ULNRC-05423

**DOCKET NUMBER 50-483
CALLAWAY PLANT UNIT 1
UNION ELECTRIC CO.
RESPONSES TO REQUESTS FOR ADDITIONAL INFORMATION
REGARDING REQUESTS FOR RELIEF FROM
ASME SECTION XI CODE EXAMINATION REQUIREMENTS
(INCLUDING WITHDRAWAL OF RELIEF REQUEST ISI-37)**

**REQUEST FOR ADDITIONAL INFORMATION
REGARDING RELIEF REQUEST ISI-34**

**REQUEST FOR ADDITIONAL INFORMATION
REGARDING RELIEF REQUEST ISI-40**

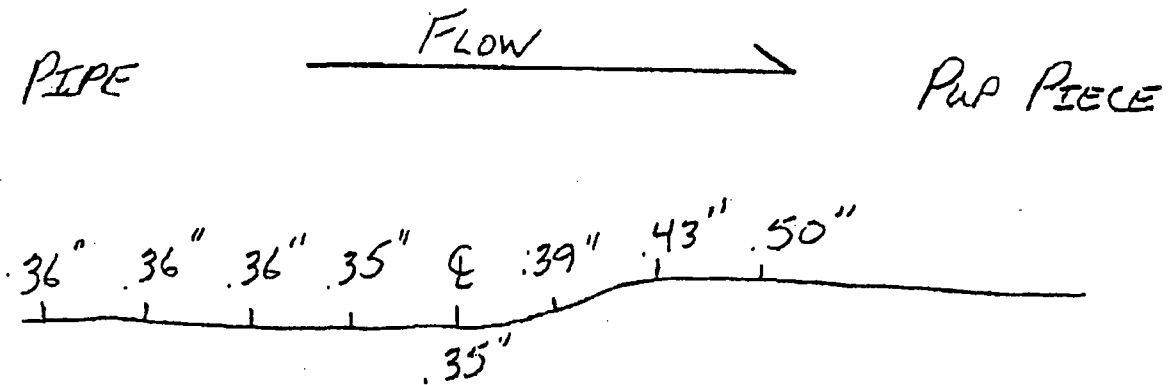
2. *The letter dated October 25, 2006, reduces the examination coverage for welds in the licensee's RI-ISI program. Discuss how the licensee's program will satisfy the minimum coverage criteria in the weld population that contributes to the percentage of the piping weld population referenced in TR-112657.*

As stated in the October 25, 2006 letter, "Using the degradation mechanism insight of Code Case N-711 and its associated white paper, Callaway Plant could take credit for examining 100% of the area of interest for the subject welds." The insights of Code Case N-711 were developed in the years following issuance and approval of TR-112657. The intent of the request for relief (ISI-34) was to incorporate those insights, ensuring that appropriate locations remain selected (i.e., welds with active degradation mechanisms) and that for each of the subject welds the appropriate required examination volume for the degradation mechanism is utilized and achieved as shown on figures "Coverage B1" and "Coverage B2."

Valve:

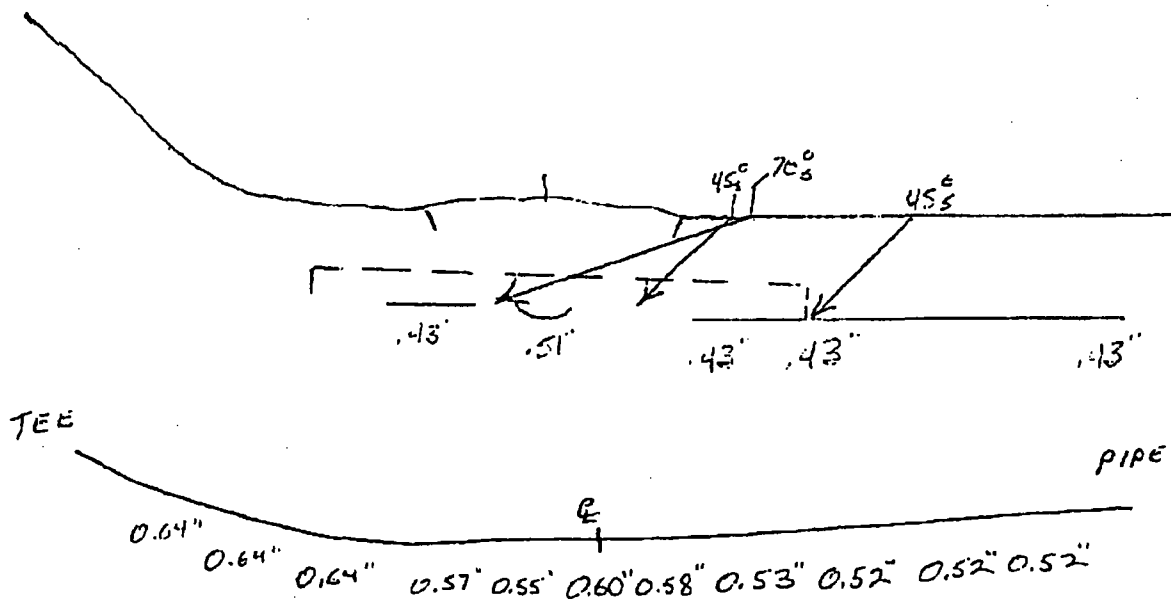
3. *The letter dated October 25, 2006 briefly listed the limitations for less than 100% coverage in the table titled "Description of Coverage Limitations." However, the table provided insufficient information to demonstrate impracticality. For each subject weld, provide a cross-sectional sketch identifying the material (carbon steel, cast or wrought stainless steel, cast or wrought nickel based alloys) in the weld region, identifying the wall thickness at the weld, and showing the interference location.*

All welds are stainless steel components to wrought stainless steel pipe welds.

The following sketches (shown on the next page), which are from the UT reports, are typical for the component welds in ISI-34

6" Pipe to Flange Weld

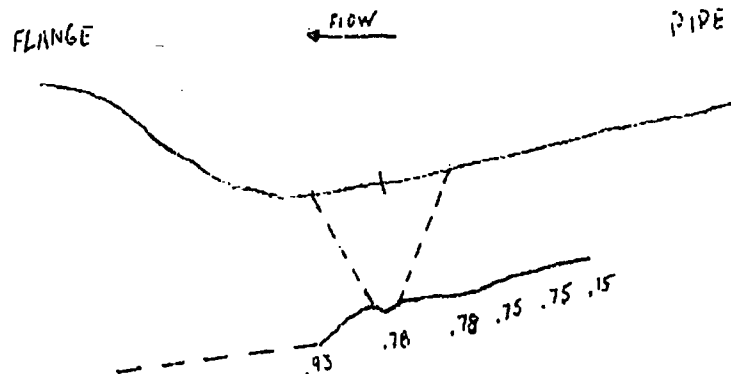
1. *Provide a cross section sketch identifying the material (carbon steel, cast or wrought stainless steel, cast or wrought nickel based alloys) in the weld region, wall thickness at the weld, and describe or sketch the location and type of interference for each weld.*

Comments: Weld Profile and Scan Limitation

All of the welds addressed by Relief Request ISI-40 are stainless steel component (flange or valve, as appropriate) to wrought stainless steel pipe welds, examined in accordance with category B-J. The examination category R-A shown on page 1 of 3 of the relief request document refers to the RI-ISI category. There are currently no RI-ISI preservice inspection (PSI) requirements provided by the ASME Code, so the PSI examination requirements revert to the Pre-RI-ISI category requirements (i.e., B-J). ASME Section XI 1989 edition Table IWB-2500-1 Category B-J Item B9.11 requires 100% volumetric examination as defined in Figure IWB-2500-1.

Scan limited to one side only due to flange, examination volume considered 50% complete in accordance with APP. VIII requirements. Best effort examination performed on the flange side using refracted L wave.
Reference UT Report #'s UT-05-041, UT-05-042, UT-05-043.

6" Pipe to Valve Weld

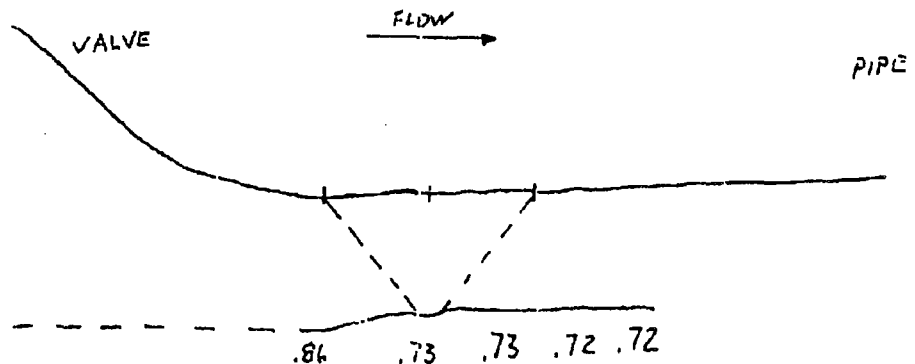
Comments: Weld Profile and Scan Limitation

Scan limited to one side only due to valve, examination volume considered 50% complete in accordance with APP. VIII requirements. Best effort examination performed on the valve side using refracted L wave.
Reference UT Report #'s UT-05-047, UT-05-048, UT-05-049.
